Addendum 1 for RFB927940-04

Project Name: WRC Decentralization Phase 4 & Fire Alarm Phase 3 (9279.40 & 9279.41) Bid Issuance #4
DAS RFB #: 927940-04
DAS Project #: 9279.40 & 9279.41
Date: 5/21/2026

CHANGES TO DRAWINGS

13-M300

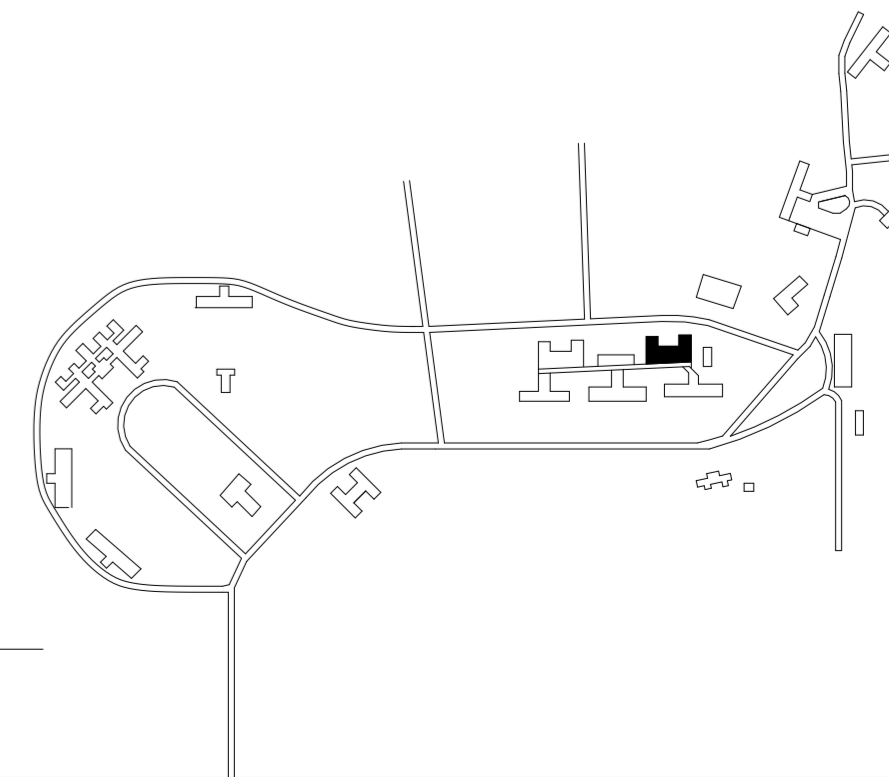
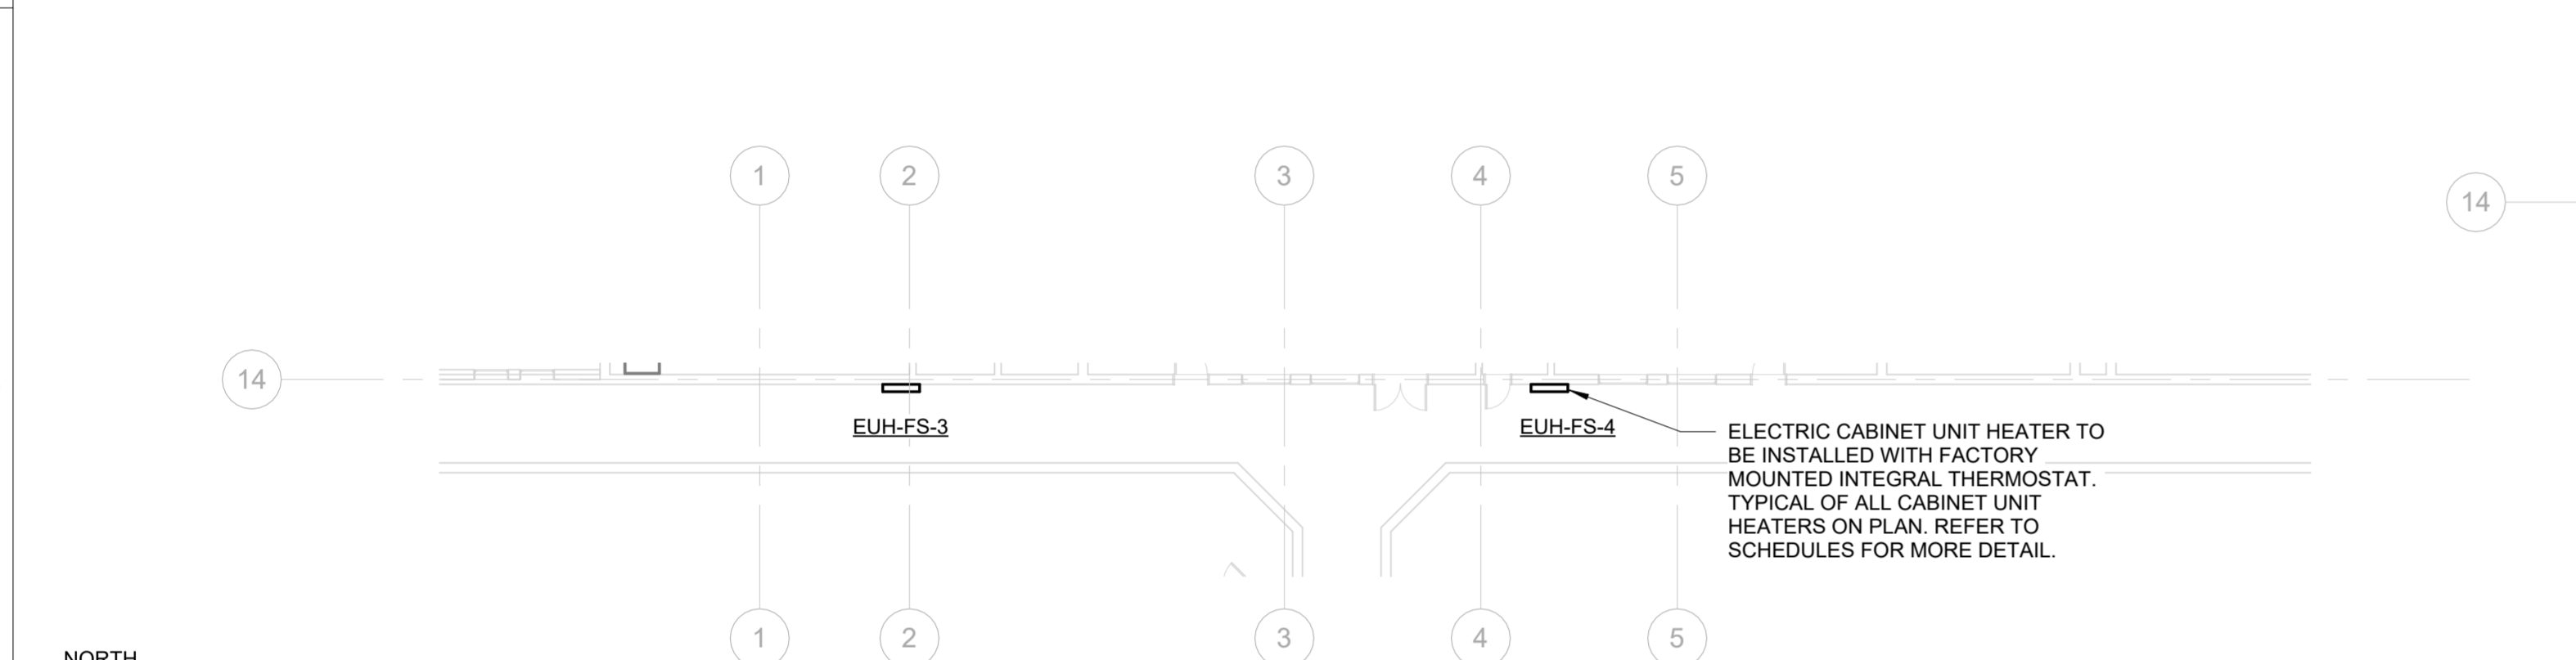
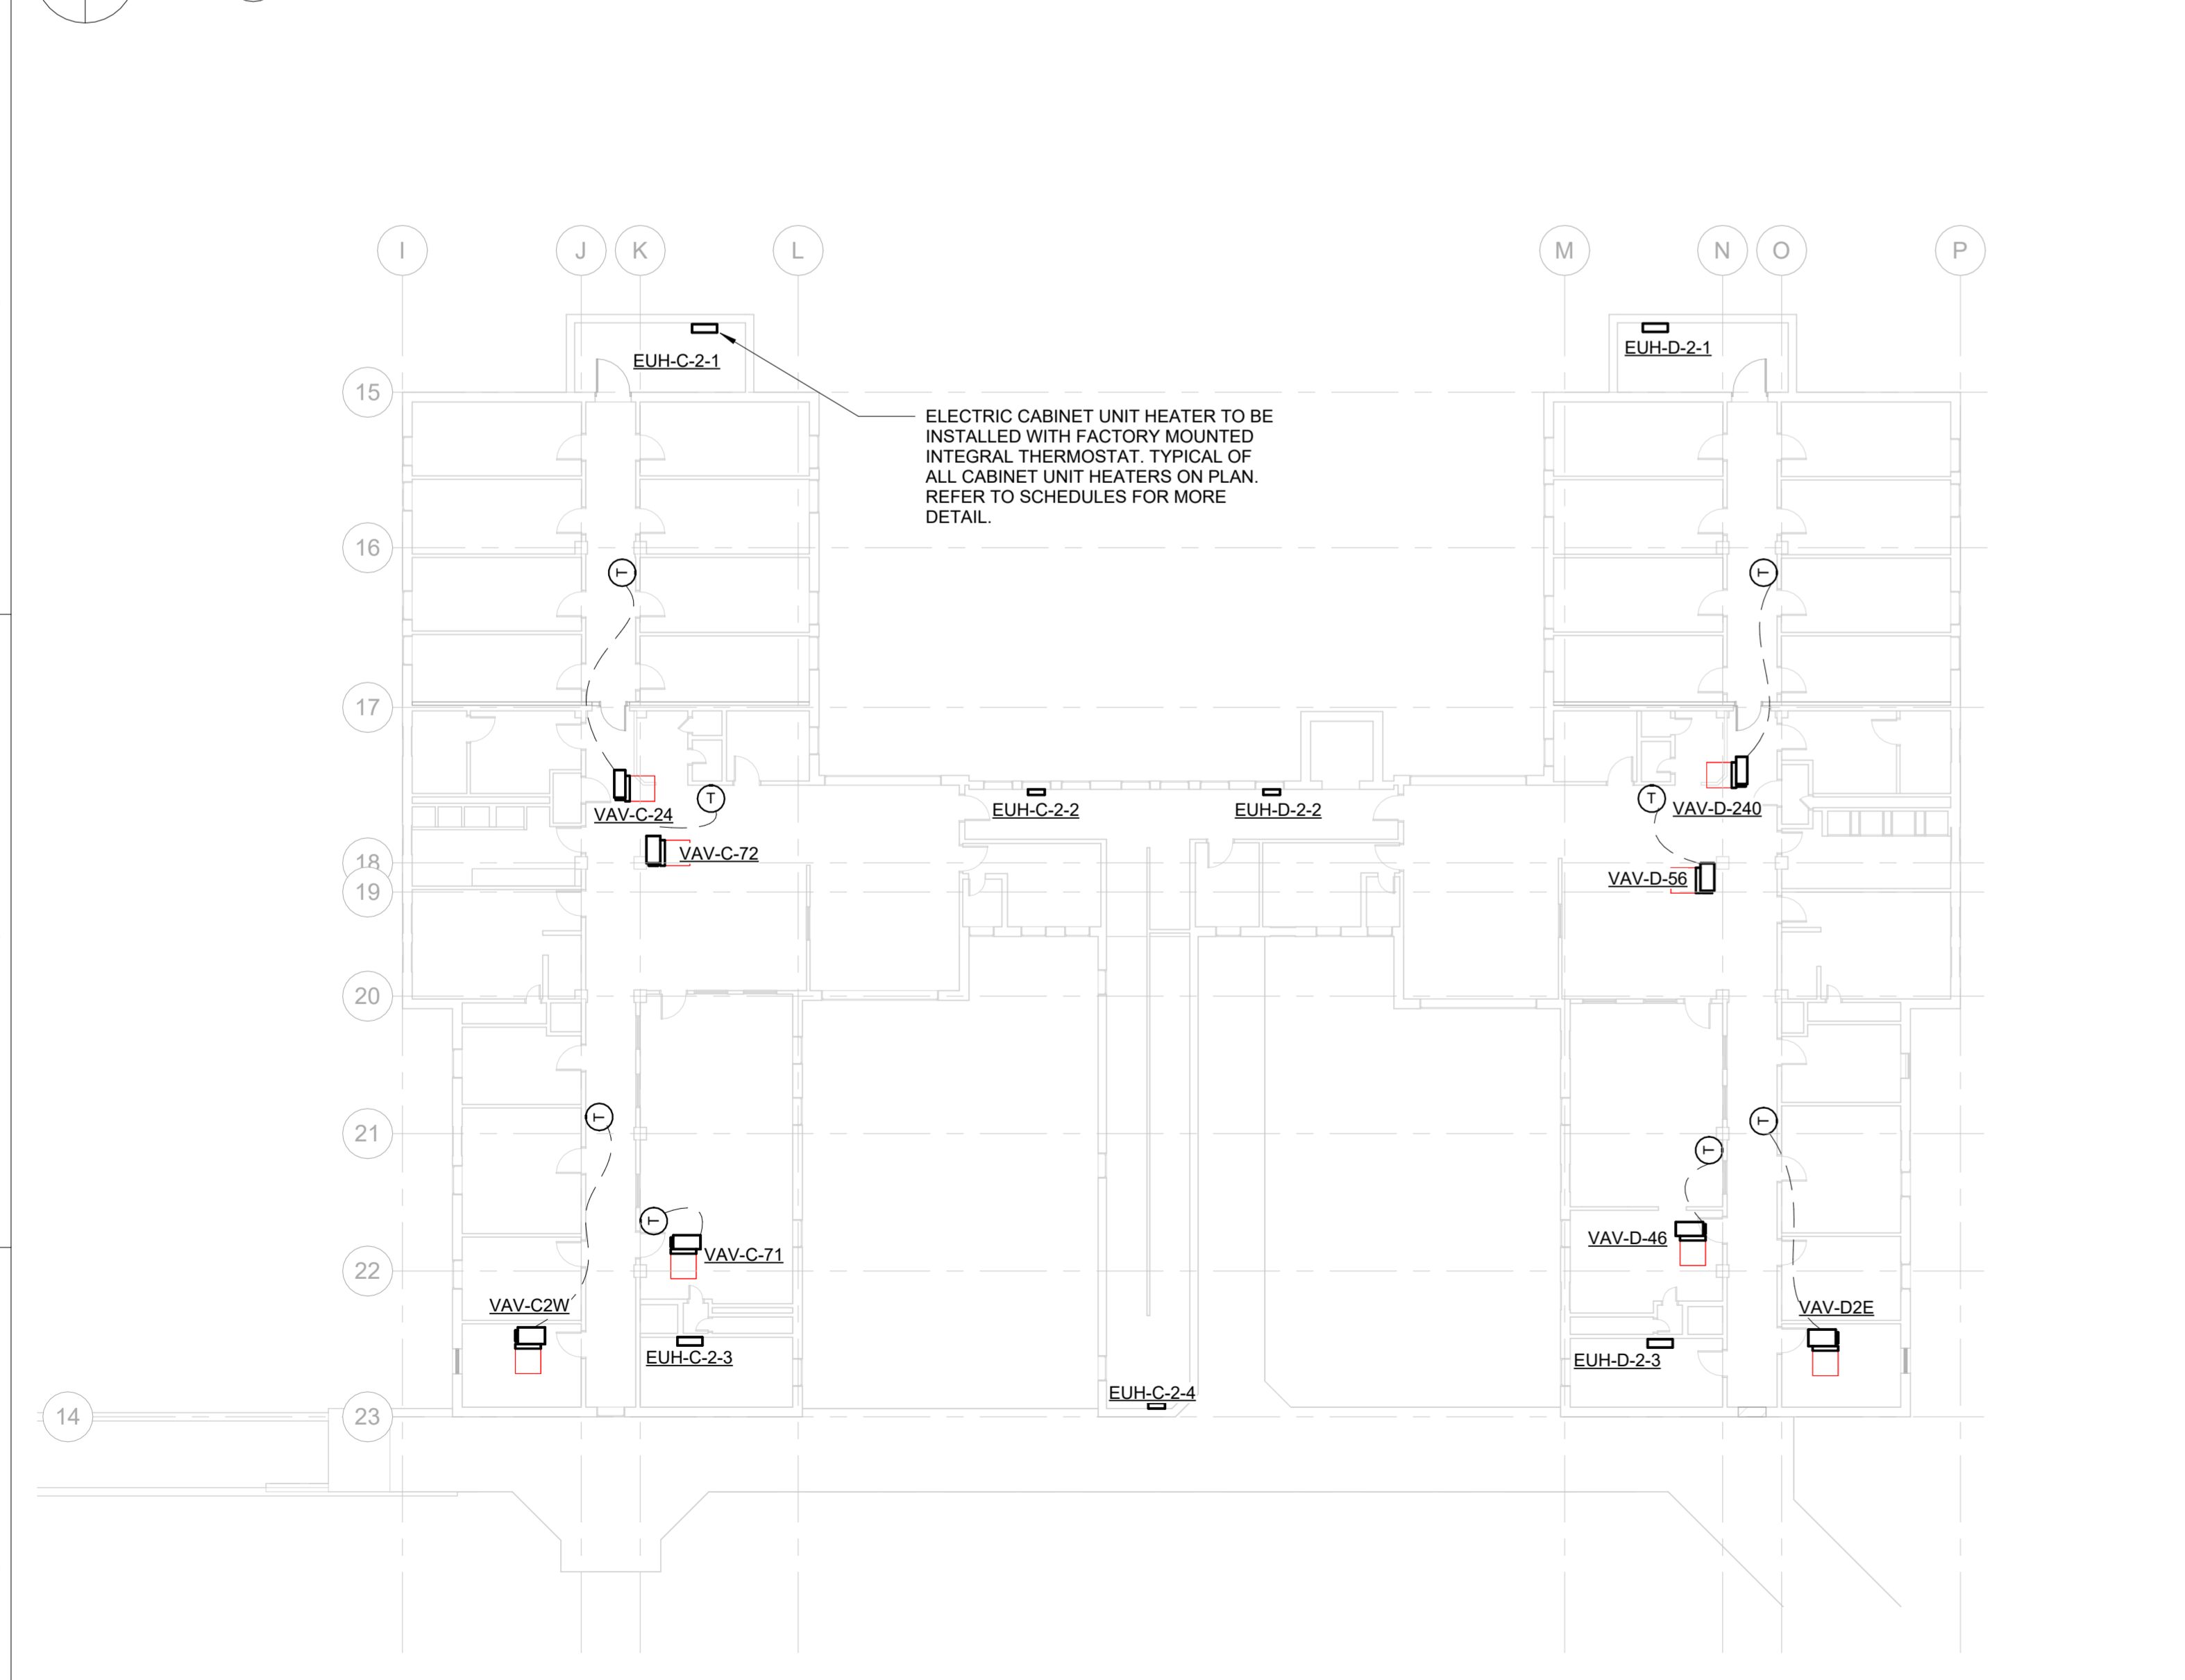
- **ADD** Keynote 13-M32
- **13-M300 – THERMOSTAT PLAN:**
 - **REVISE** thermostats in Area D Basement.
- **13-M501 –MECHANICAL CONTROLS:**
 - **ADD** ERV control sequence.
